Project	IEEE 802.16 Broadband Wireless Access Working Group < http://ieee802.org/16 >	
Title	Multiple Broadcast Maps for OFDMA PHY	
Date Submitted	2004-11-17	
Source(s)	Ran Yaniv, Tal Kaitz, Vladimir Yanover, Naftali Chayat Alvarion Ltd.	ran.yaniv@alvarion.com tal.kaitz@alvarion.com
	Hang Zhang, Mo-Han Fong, Peiyong Zhu, Wen Tong Nortel Networks	mhfong@nortelnetworks.com
	Yuval Lomnitz Intel	yuval.lomnitz@intel.com
	Dave Pechner, Todd Chauvin, Doug C. Dahlby ArrayComm	dpechner@arraycomm.com chauvin@arraycomm.com dahlby@arraycomm.com
	Bin-Chul Ihm, Yongseok Jin, Jinyoung Chun, Kyuhyuk Chung LG Electronics, Inc.	bcihm@lge.com jayjay@lge.com jychun03@lge.com kyuhyuk@lge.com
Re:	Call for contributions, IEEE P802.16e/D5 Sponsor Ballot	
Abstract		
Purpose		
Notice	This document has been prepared to assist IEEE 802.16. It is offered as a basis for discussion and is not binding on the contributing individual(s) or organization(s). The material in this document is subject to change in form and content after further study. The contributor(s) reserve(s) the right to add, amend or withdraw material contained herein.

Multiple Broadcast Maps for OFDMA PHY

Figure 229a – Illustration of DL sub-frame structure with multiple broadcast maps in the first DL zone.

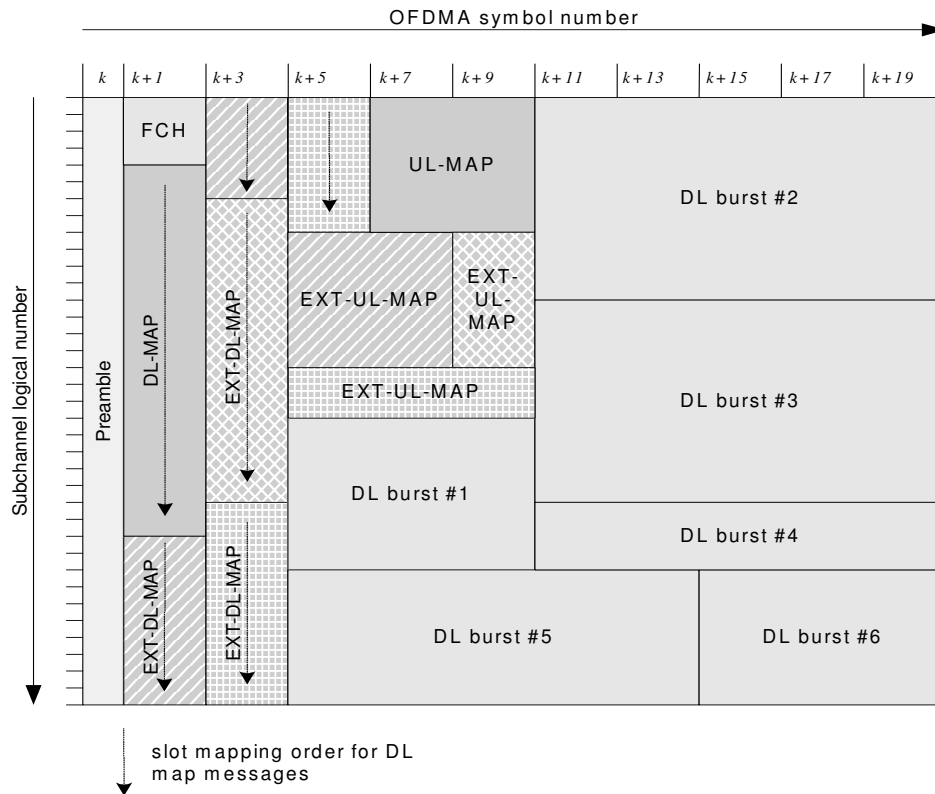
The bursts containing the EXT-DL-MAP messages shall only be described by an EXT-DL-MAP-LIST IE. This IE (if exists) shall immediately follow a STC_ZONE IE to describe EXT-DL-MAP messages that are located in that zone. It shall appear as the first IE in the mandatory DL-MAP when describing EXT-DL-MAP messages located in the first zone within the frame.

The number of EXT-DL-MAP messages in a zone shall not exceed 3. The structure of the DL sub-frame with multiple broadcast maps is illustrated in figure 229a.
